#5752

ON-SITE SEWERAGE FACILITY LICENSE
Issued by The Lower Colorado River Authority
An Authorized Agent of the Texas Natural Resources
Conservation Commission (TNRCC)

Re: Application No. 5752.10, Lake Buchanan, Indian Hills Store, Lot 491

PERCOLATION TEST REPORT

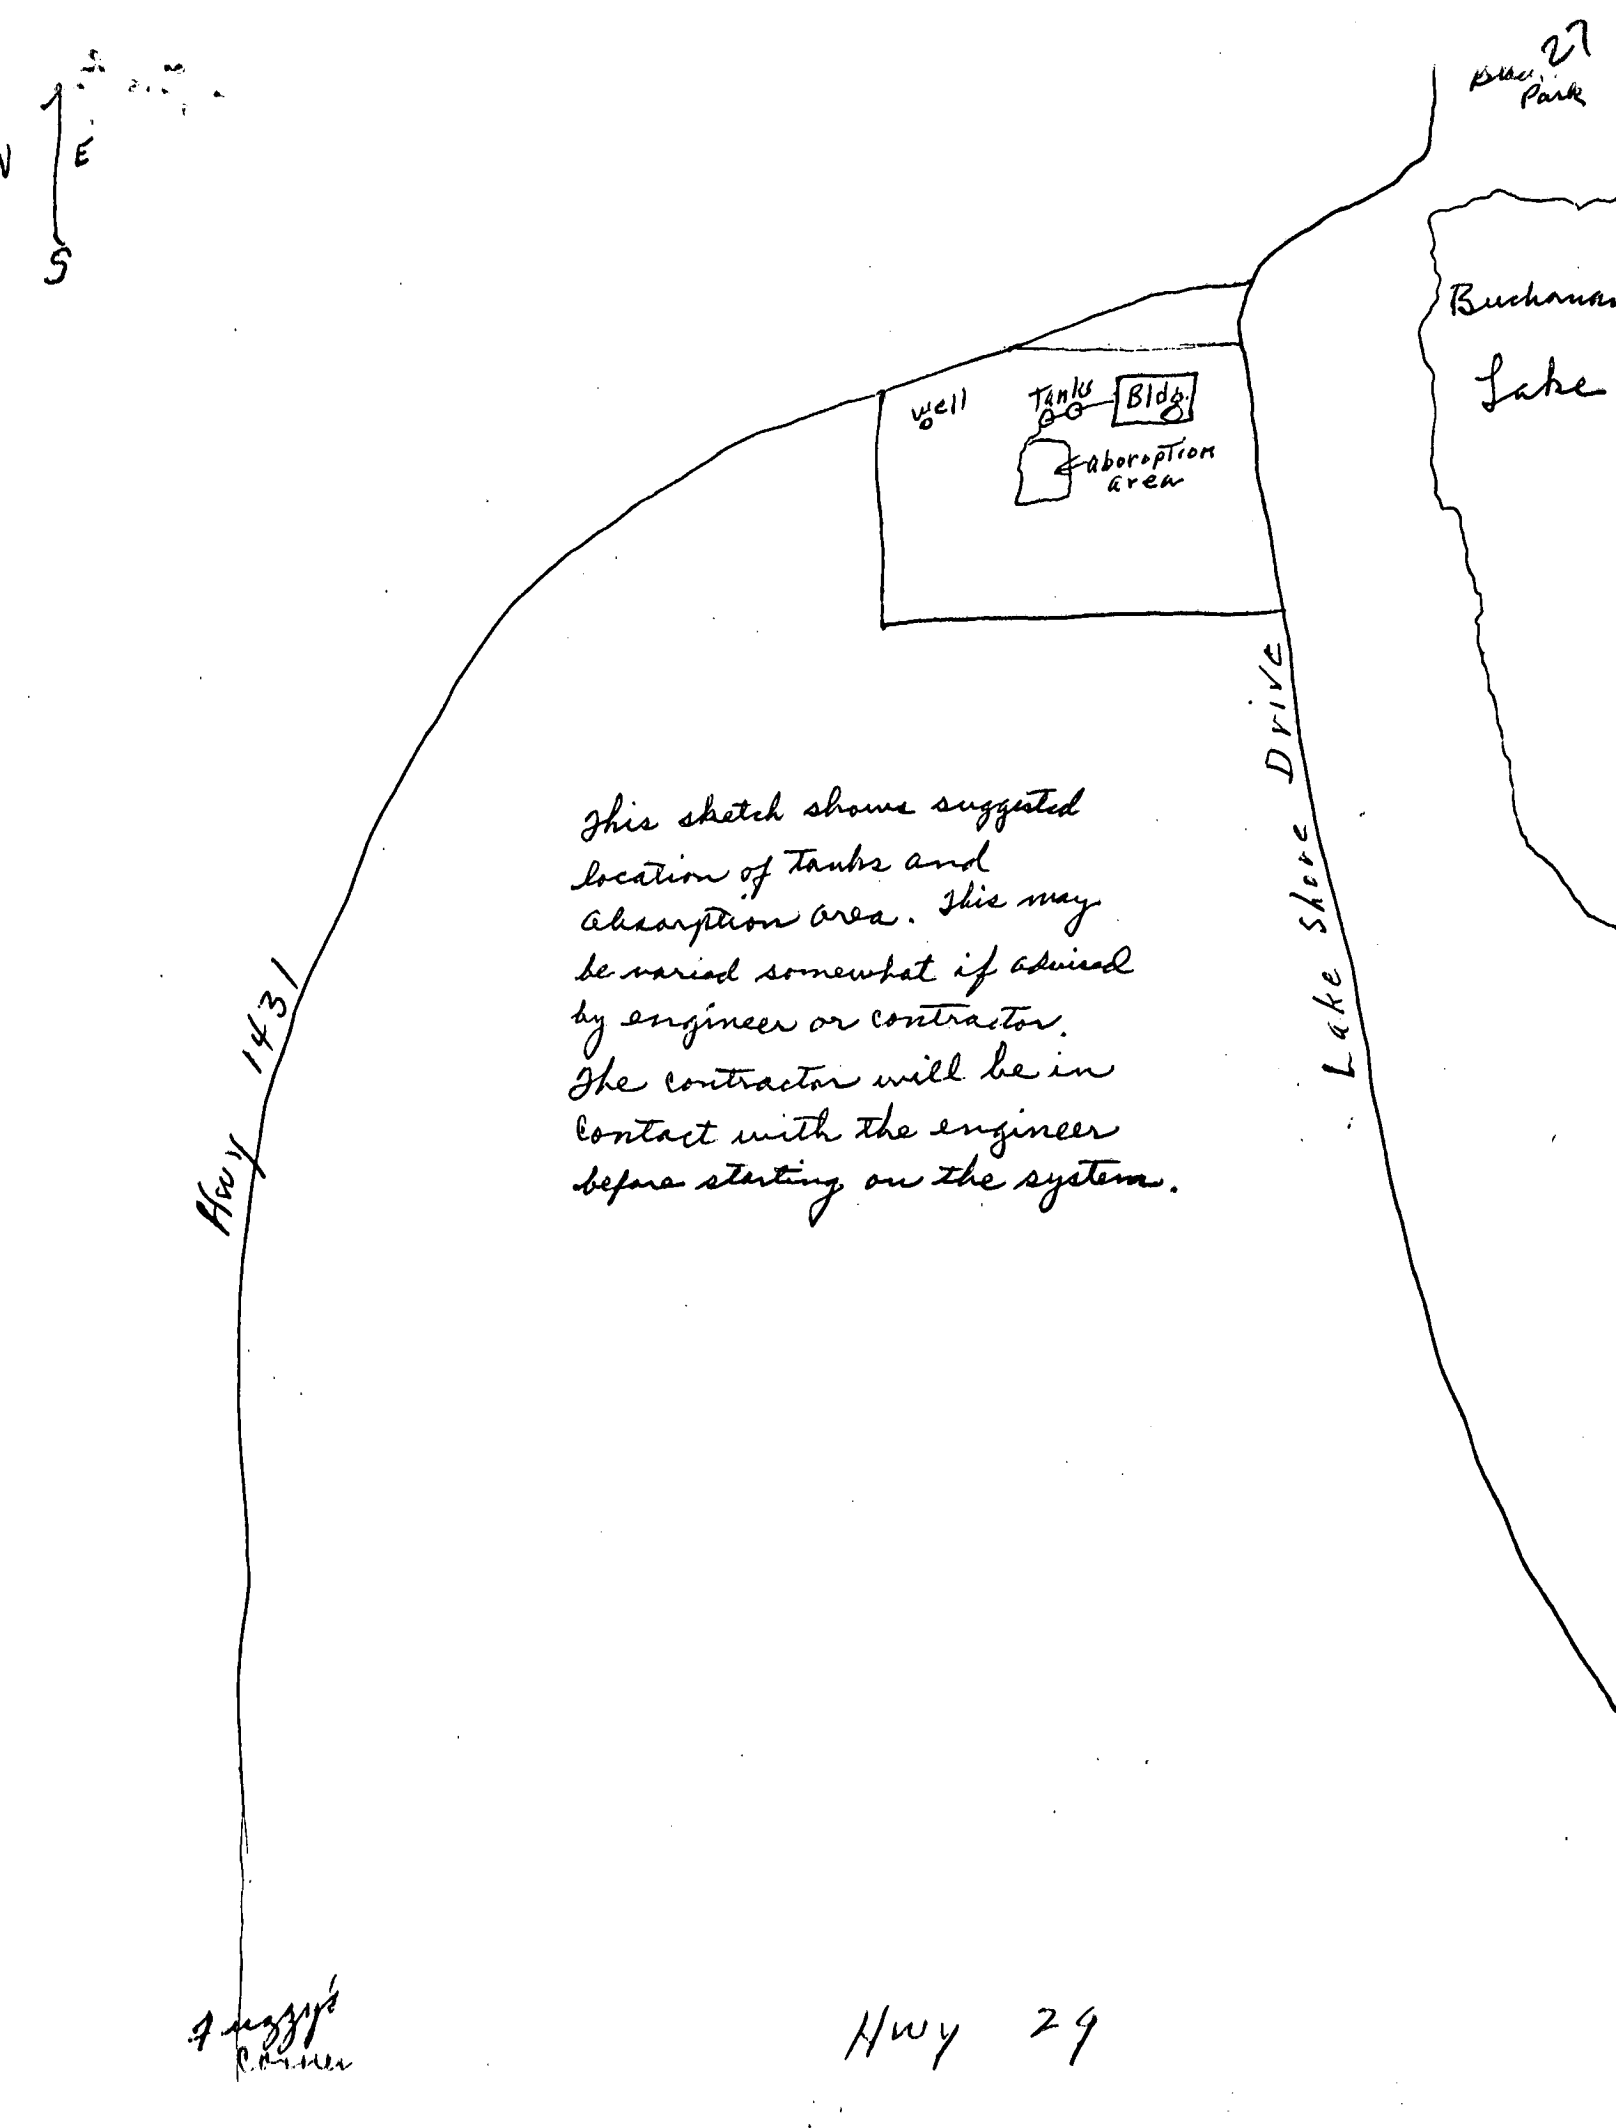
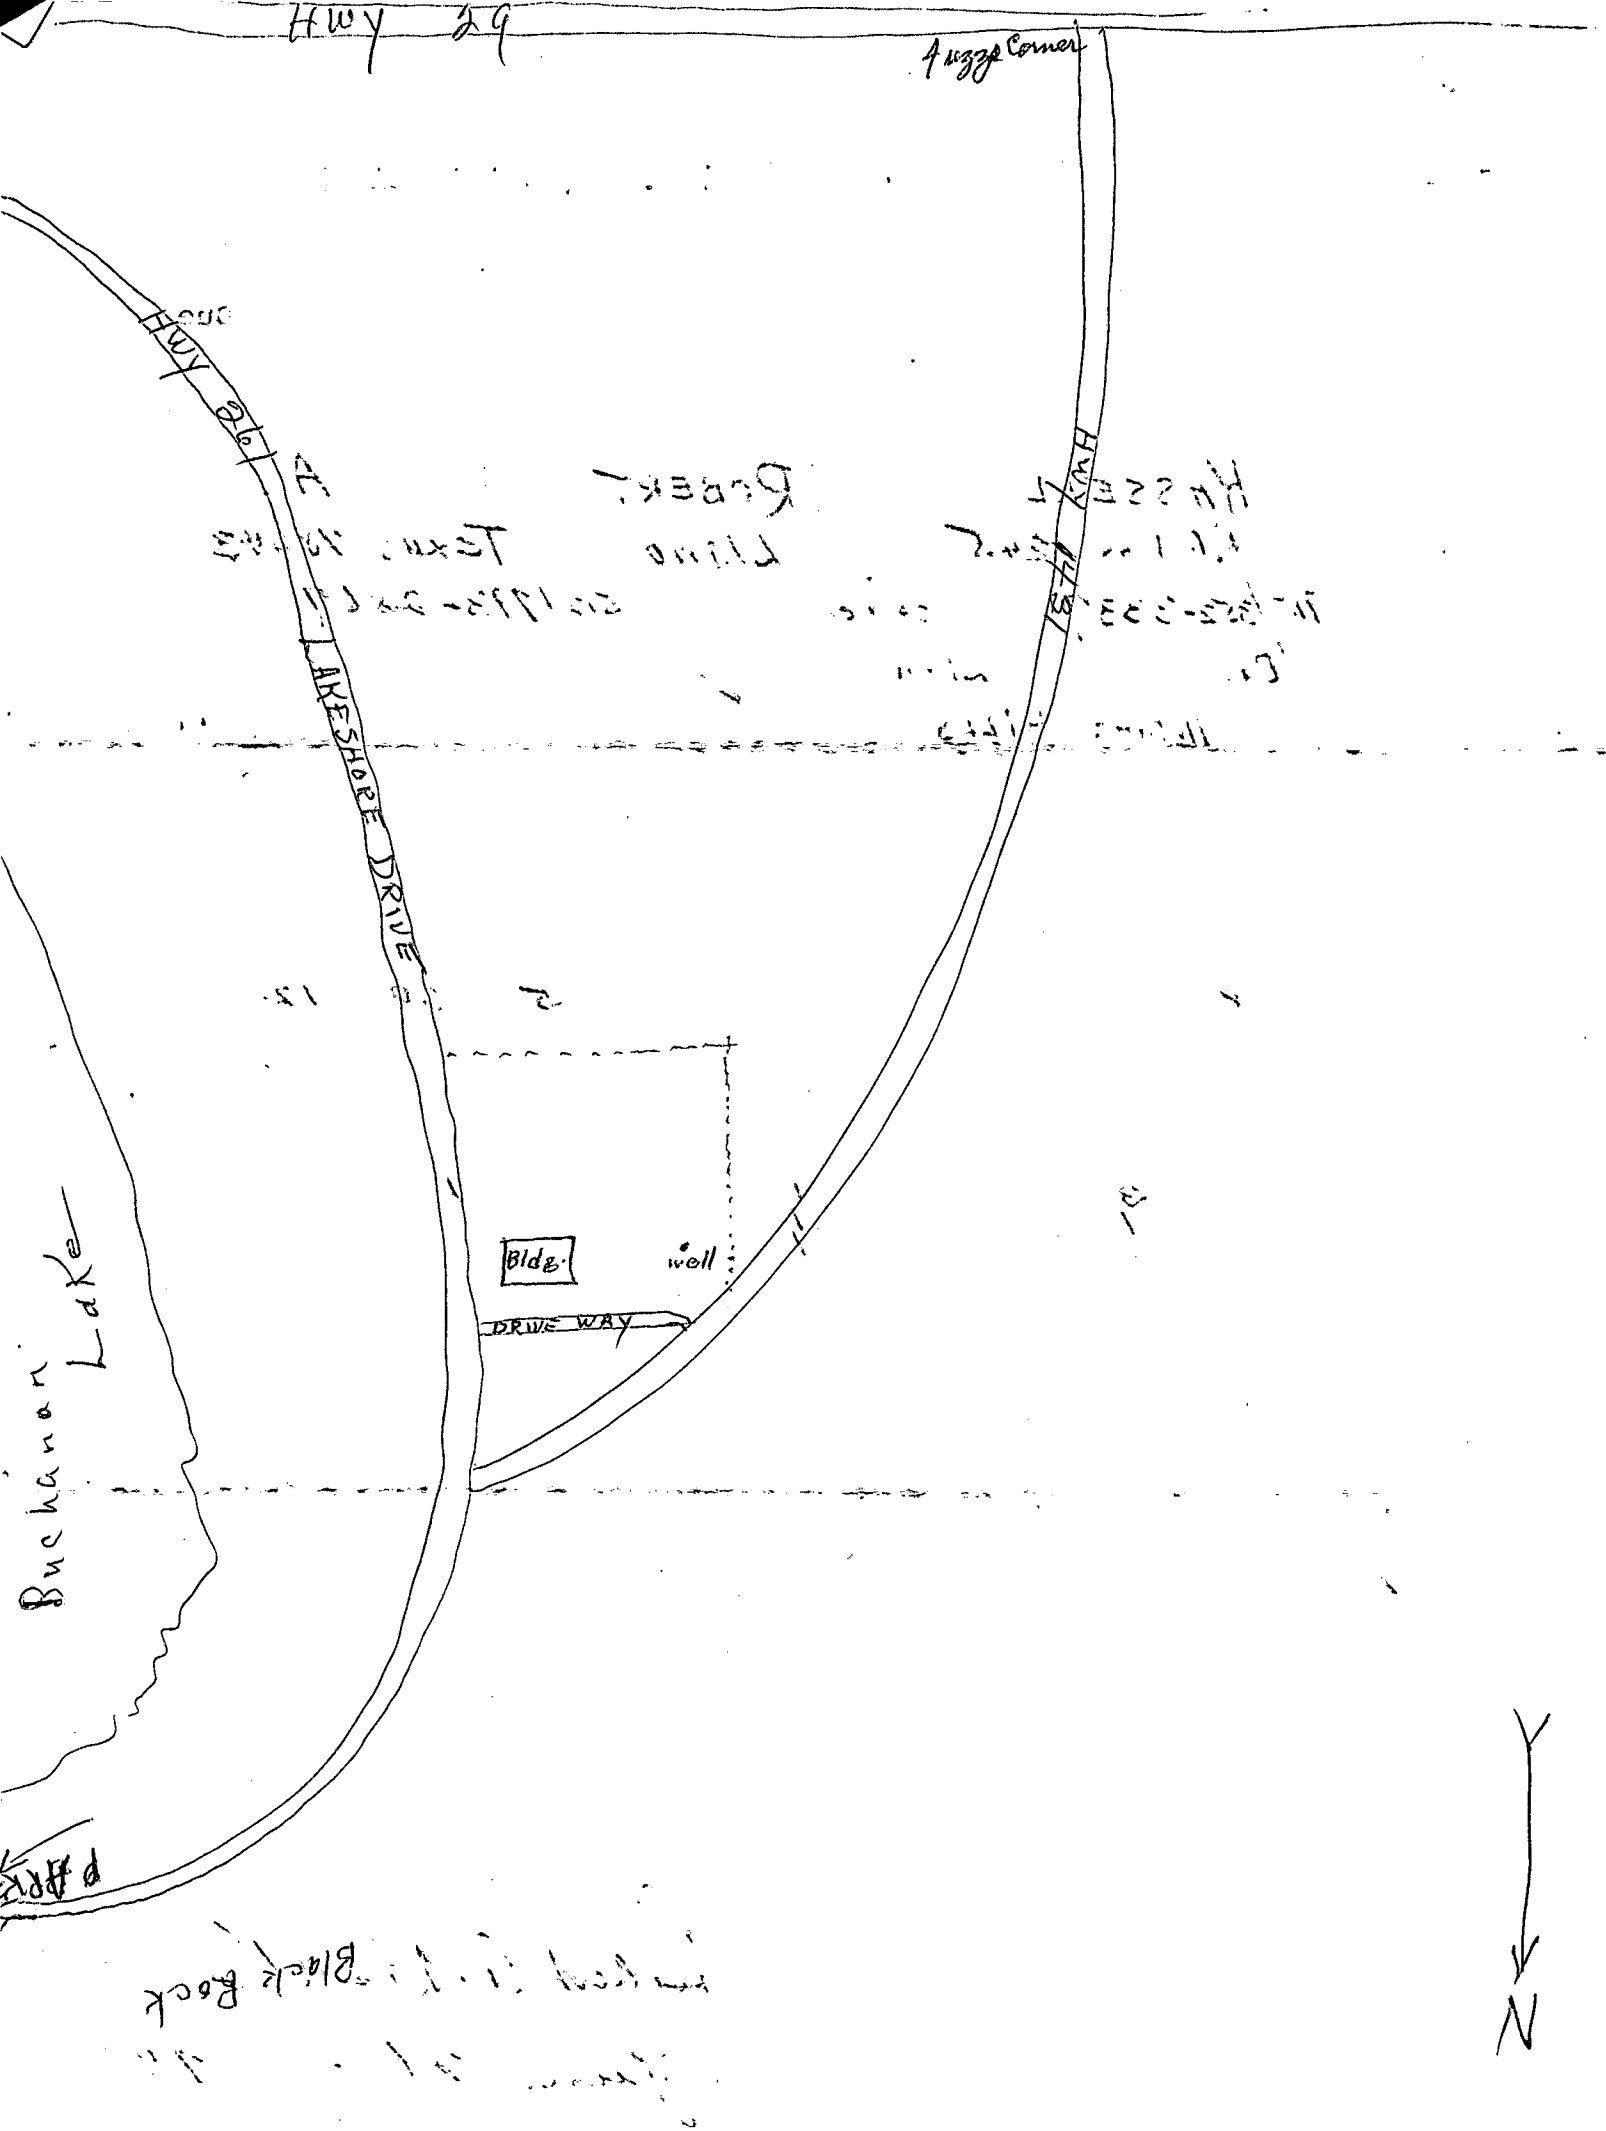
1. System is in Water Quality zone; ±250' feet to lake
2. Wells within 150' feet? None. Locate on sketch
3. Soil conditions granite gravel + clay mixture
4. Is proposed location approved? Yes
5. Ground level? OK
6. Special remarks and conditions Backfill material must be a sandy loam. System will store + living quarters, bathroom is for living quarters only. 2 tanks or 2 compartment tank required. 1510 ft required, two beds are required with NO one more than 1000 ft.

This sketch shows suggested location of tanks and absorption area. This may be varied somewhat if advised by engineer or contractor. The contractor will be in contact with the engineer before starting on the system.

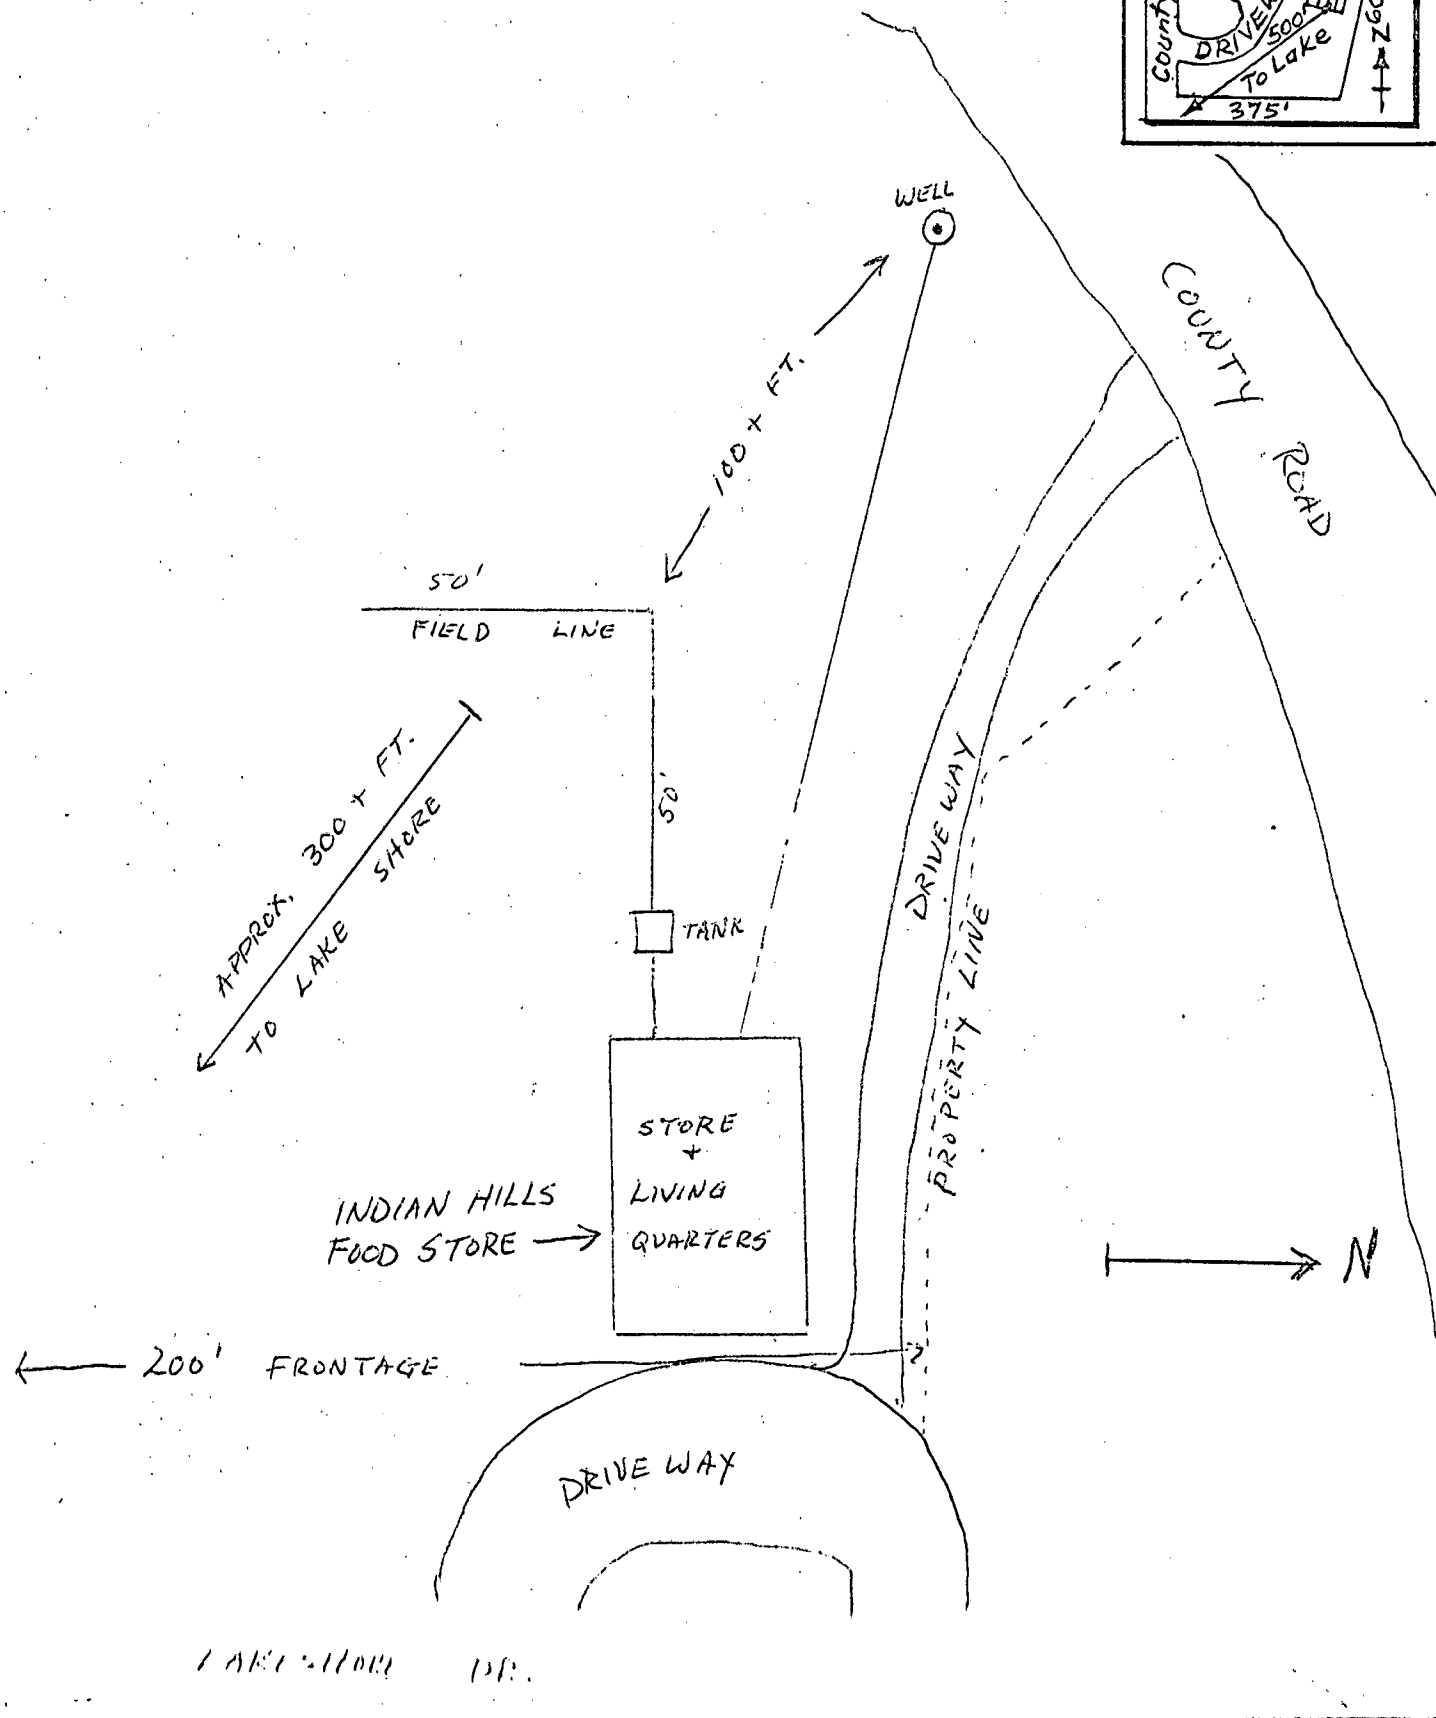
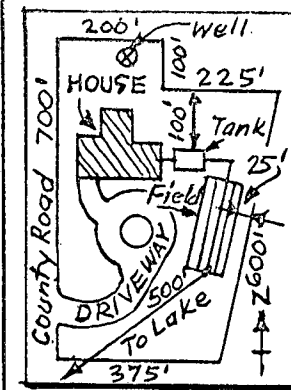
COMMENTS: System is installed as shown on the sketch but it is not operating properly at this time. While probing for the tank water was observed bubbling from several holes in the probable tank location several more shallow holes were made & each filled & bubbled. The surrounding ground is wet & soft enough to rut 2-3" deep from a pick-up truck driving over the area. Owner was present during the inspection & intends to have immediate repairs made. Will follow up in 2 or 3 days
